25/03084/RM

Reserved matters application for approval of layout, scale and appearance of buildings and landscaping pursuant of outline permission 21/00504/OP granted 03.04.2025 for residential development comprising of up to 120 dwellings with vehicular access via Flint Road

Land To The East Of Talbot Way And Kristiansand Way And Flint Road Allotments Flint Road Letchworth Garden City Hertfordshire SG6 1TY

MOVEMENT AND ACCESS – Edward Leigh (Senior Transport Policy Officer)

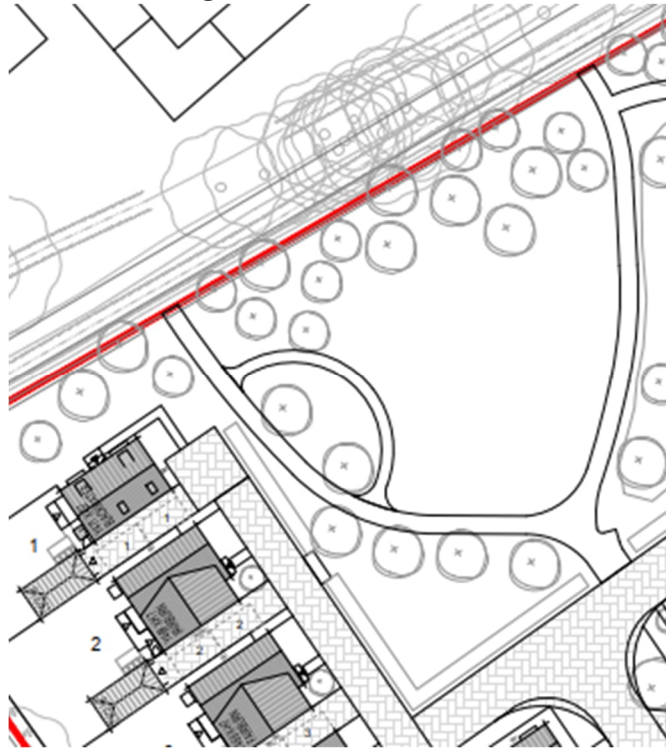
Layout	• The active travel links to the public right of way at the north-western boundary of the site are shown as recreational paths approximately 1.75m wide, which is well below the 3m recommended for shared use (recognising that the outline application expects footpath 026 to be upgraded for cycling). • Many driveways are too narrow to accommodate parked cars and manoeuvre bikes and bins: for instance, the driveway for plots 100/101 is ~5.6m wide wall-to-wall; subtract 4m for two SUVs and it leaves just ~1.6m width for wing mirrors, to open doors and move bikes and bins. The driveway to plot 98 narrows to 3.2m, leaving ~1.2m around the car. • This situation must be avoided:

- There is wide inconsistency in the widths of passageways to gardens, ranging from ~0.9m (plot 17) to ~1.5m.
- Although 1.5m width for passageways is ideal, it compromises significantly the garden space for plots 11 and 23. 1.2m with chamfered corners is acceptable.

- Plot 7 has the garden gate to the side of a parking bay, access to which would be blocked by a parked car.
- The disabled parking bay for plot 45 is not compliant with standards: the bay is only 2m wide and one side is not protected from vehicle movements.

- How will the shared bays for apartments be managed?
- The waste strategy requires vehicles to make multiple reversing manoeuvres, more than the recommended 12m in several instances.

- Bin collection points are up to 25m (for plots 18–20) from where waste vehicles will reach, and up to 20m from apartment bin stores (plots 67–75), which are both significantly in excess of guidance from Waste Services.

1. Provide cyclable routes to reach the public right of way to go west (to Green Lane) or east (to St Nicholas primary school), e.g. by adding a path from the driveway at plot 1 and widening the eastern arm of the 'wishbone' path through the POS.

2. Adjust driveway widths to ensure that there is 1.2m clear space for moving bikes and bins when a 2m-wide car is parked. For a single-width driveway (adjacent to a wall or another property's driveway), this requires $0.6 + 2 + 1.2 = 3.8\text{m}$. For a double-width driveway, this requires $0.6 + 2 + 0.6 + 2 + 1.2 = 6.4\text{m}$.
3. Adjust the widths of garden access passageways to be a minimum of 1.2m with chamfered corners at bends. Any reduction from that width at pinch points must

take into account protruding elements from walls, such as meter cupboards, window sills, outward opening windows, soil and drain pipes, etc. 4. Show the location of EV chargepoints to demonstrate that charging cables will not obstruct access for bikes and bins. 5. Describe how shared-allocation bays for apartments will be marked/signed. 6. Relocate the garden access for plot 7. 7. Relocate or redesign the disabled parking bay for plot 45. 8. Relocate bin collection points to allow kerb-side collection from houses and no more than 10m drag distance from apartment bin stores, unless agreed otherwise with Waste Services. 9. Re-plan the waste collection route with the edge lane connected at plot 89, and agree reversing distances with Waste Services.
--	--

Figure 33 Plan showing the access and movement framework

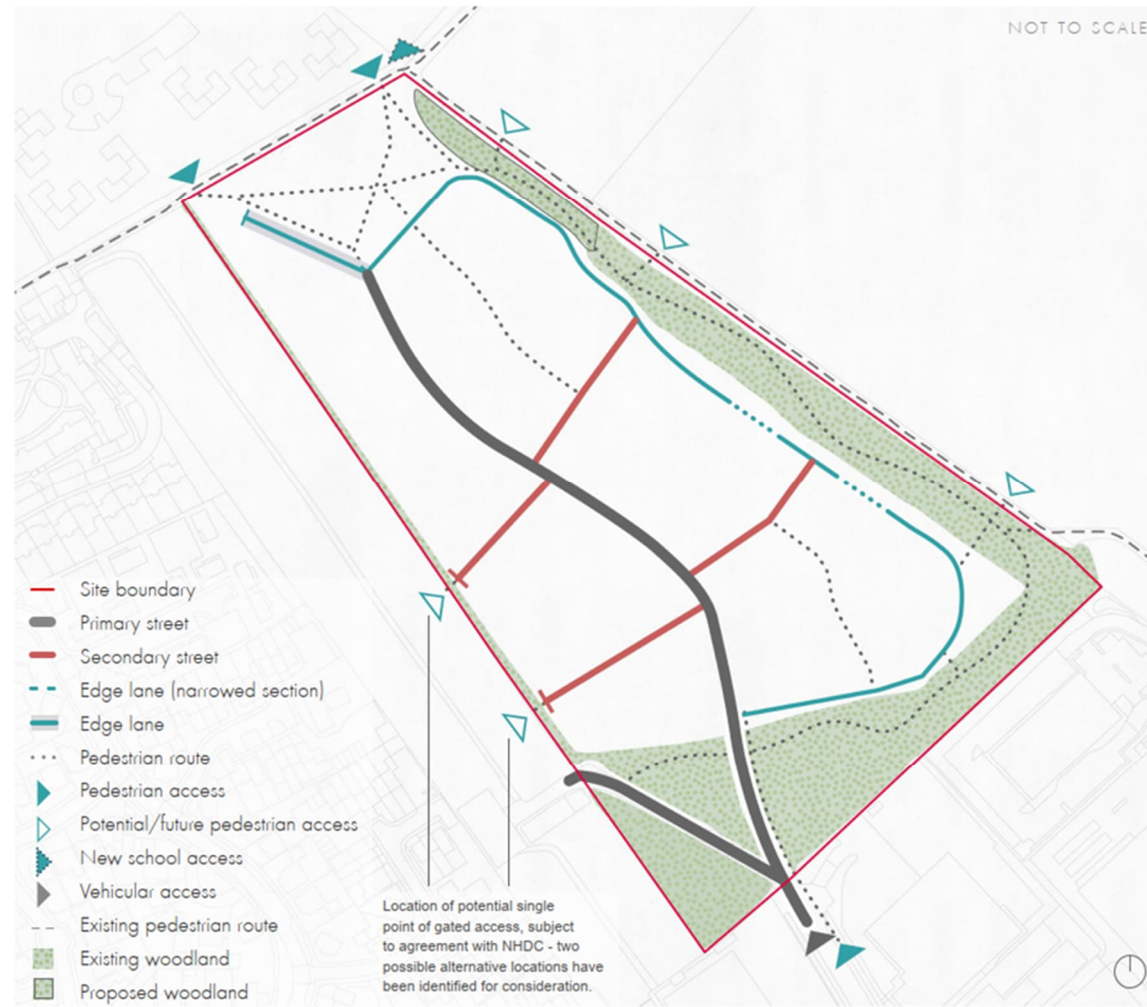
Requirement	Comments
The approved framework plan (below) identifies three connection points to the eastern boundary. These are illustrated on drawings but not definitely proposed i.e. optional. Should all of these be secured – i.e. do they all serve a different purpose? If not, which ones are unnecessary?	• These are leisure routes, and therefore their inclusion and location are not critical. Nevertheless, the expectation is that they will be provided unless the applicant provides evidence why it is not appropriate or feasible to provide them.
Rural edge design code
